AGENDA
PLANNING AND ZONING COMMISSION MEETING
CITY OF CREVE COEUR, MISSOURI
MONDAY, JULY 18, 2022
6:00 PM

**APPLICATION TO PLANNING AND ZONING COMMISSION
#22-012: MINOR SITE PLAN FOUR ELECTRIC VEHICLE CHARGING
STATIONS AND ACCOMPANYING EQUIPMENT LOCATED WITHIN
PLAZA SHOPS AT 745 NORTH NEW BALLAS ROAD**

REPORT PREPARED BY: Bethany L. Moore, City Planner

Figure 3: Detail of the site proposal with new EV stalls, equipment and screening.

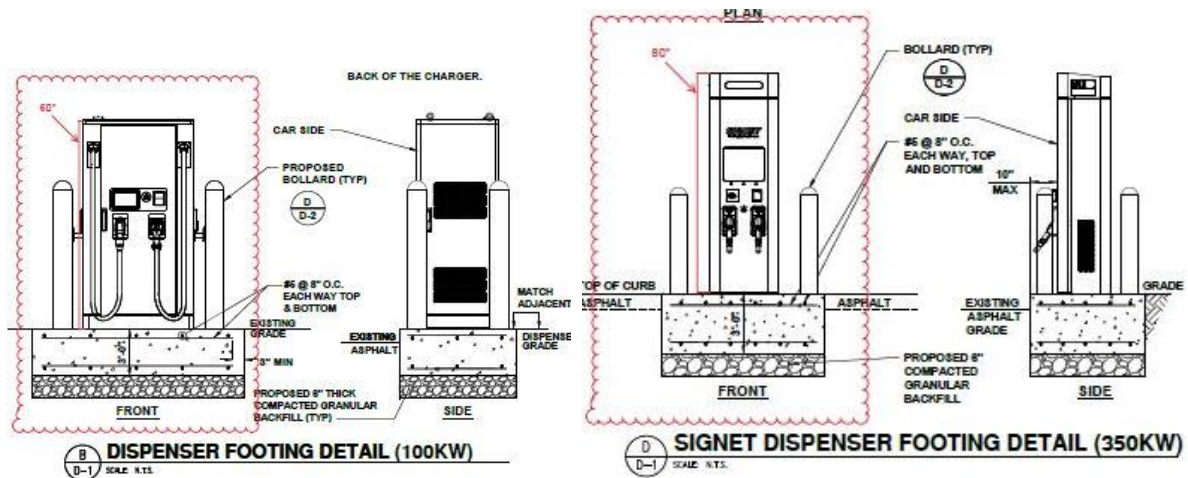
The Design Guidelines provide specific guidance for the screening of all exterior trash and storage areas, service yards, loading docks and ramps, wood service poles, electric and gas meters, irrigation back flow prevention devices, and transformers with fences and walls including that they are to be screened from view in a manner that is compatible with the building and site design. Screening materials should be the same as the primary building materials. The location of such services should be sited with limited visibility to pedestrians and/or adjacent properties (p.19). The guidelines also encourage landscaped parking islands to be incorporated into all parking lots. These parking islands should be located at the beginning and end of all parking aisles as well as every 8- 10 parking stalls or other landscape breaks to large parking areas. Where parking aisles have less than 16 continuous stalls, they should be placed in the middle of the aisle. Landscaped parking islands must be a minimum of 9-feet in width (p.19). The applicant’s proposed site plan and screening elements do not appear to be in conformance with the

screening and parking design goals of the Design Guidelines. If the Planning and Zoning Commission determines that the proposed location is acceptable, staff asks that a condition to replace the 6-foot-tall fence around the equipment with more evergreen landscaping be added.

island in the parking lot is removed to accommodate the EV charging equipment, the lost landscaping area will have to be made up elsewhere on the site. Staff has added this as a condition of approval.

1. The applicant is required to submit a final Landscape Plan to staff that shall be in substantial conformance with the plans received June 22, 2022, as bound together and submitted in conjunction with Application #22-014, with the addition of more evergreen trees to screen the equipment from view without a fence and including a plant schedule listing the types of evergreen trees proposed to screen the equipment.

4. The applicant shall provide existing and proposed site coverage calculations to ensure the existing non-conforming site coverage is not intensified and shall install additional landscaping elsewhere on site if the existing site coverage percentage is intensified.
